Churchill West Development Plan Addendum 2023

September 2023

Reference: 24601

Churchill West Development Plan Addendum 2023

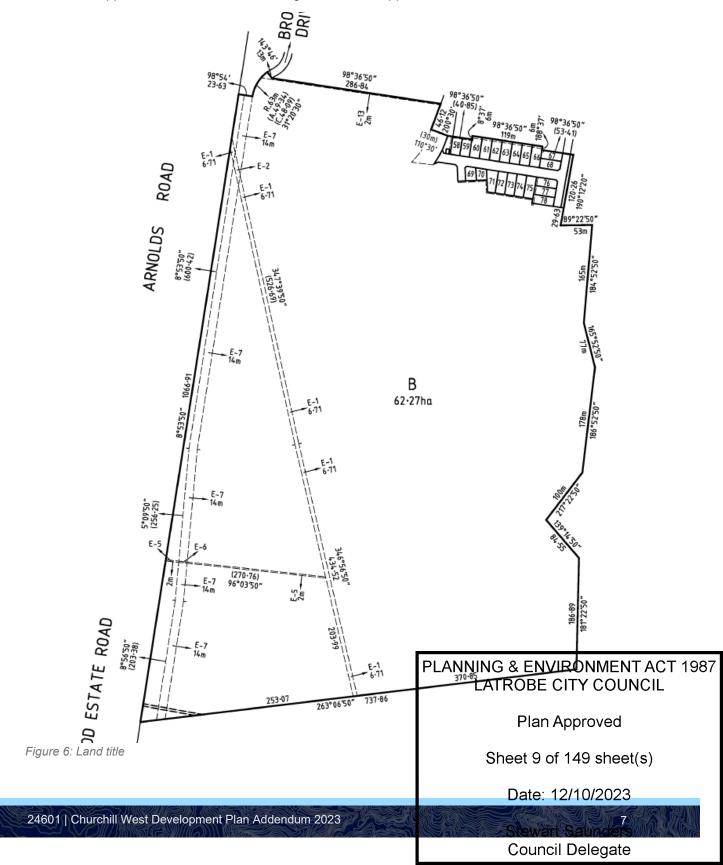
The proposed changes to the approved DP include:

- The conversion of some of the western parcels into larger low density residential (rural
 interface) lots, this provides an appropriate interface with the existing farming land to the
 west and provides more variety for those seeking lifestyle allotments.

- The previously approved integrated housing site located in the south east corner has been reconfigured to provide a medium density site and is sought to be an improved design outcome that can accommodate multiple dwellings, internal road network and landscaping. Two additional medium density sites have been proposed, one located opposite the large open space reserve centrally located and the other located to the south of the existing integrated housing site. The overall changes will see a negligible change in lot yield, however, provide a greater diversity of lot sizes to meet the changing needs of the population.

- It is proposed to change some of the internal road (access 1 street) from 18m to 16m. A new cross section has been proposed and is included as part of the proposed amendment to the Development Plan.

- The overall lot yield has changed with the amended Development Plan proposing 680 lots.
 This is an increase of 11 lots from the current approved Development Plan. The overall lot
 yield increase is minor and doesn't impact on the overall purpose of the Churchill West
 Development Plan.

Figure 8: Indicative plan of which access 1 street have been narrowed from 18 metres to 16 metres.

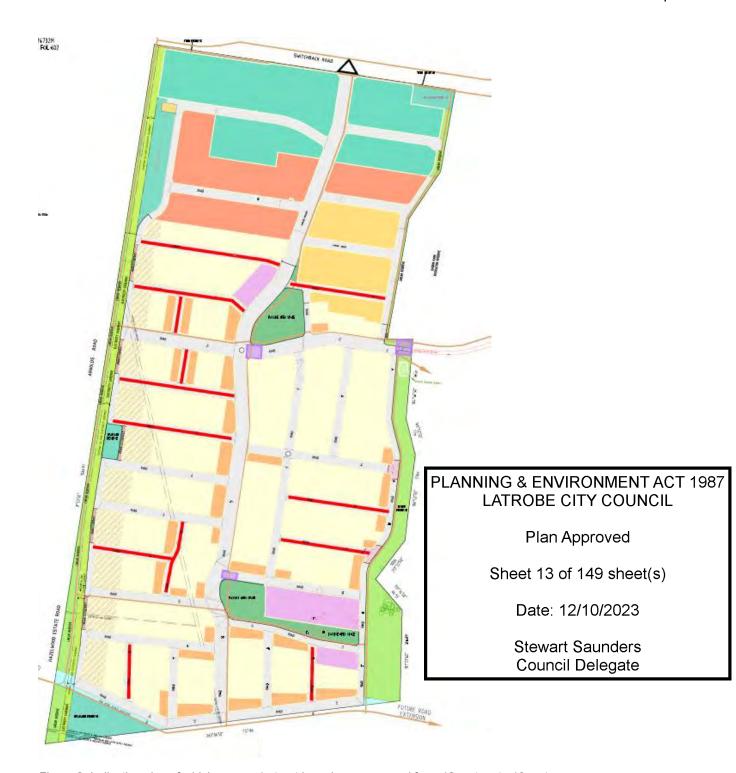
The amendment to the Development Plan does not vary greatly from the previously proposed Road Hierarchy and Movement Network Plans, whilst some proposed access 1 streets have narrowed, they are still to remain with the same street identifier. Figure 7 shows which streets have been narrowed as per the amended DP, it is noted that the narrowed street in Stage 5 has already been approved by Council.

A new cross section has been proposed and is included as part of the proposed amendment to the Development Plan. It is proposed to change some of the internal road (access 1 street) from 18m to 16m. It is considered that the variation in road widths relates strongly to the road network of the existing township ensuring that the character/connection is continued. It is noted that there is ample space within the 16m wide street reserve for the provision of tree plantings and that both stages 5 and 6 have both been endorsed with 16m road reserves as such therefore supports that a slightly narrower street reservation can be supported. There are 9 streets in total that are proposed to be reduced from 18m down to 16m, with 9 roads maintaining the 18m width. The below provides a demonstration of streets within Churchill that have a 16m road width.

The proposed narrowing in road widths is simply to factor in projected vehicle volumes, the 16 metre wide roads are not expected to see the same volumes of traffic as the 18 metre wide roads and a reduction in width is considered to be an appropriate response, to make the most efficient use of the land by placing this additional space back into residential lots.
